JULIAN
TECHNICAL SERVICE BULLETIN #27

Product: Julian

Re: **Corrective action**- replacement of Man/Spont-Auto switchover diaphragm located in valve plate of the breathing system.

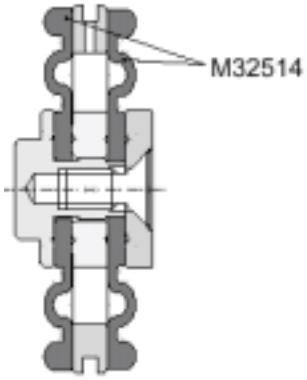
Solution/Procedure: Replacement of individual diaphragms of diaphragm assembly for Man/Spont-Auto switchover.

Notice: When fitting the diaphragm(s), pay special attention to the correct fitting position (see drawing). Secure the screw with Loctite 221.
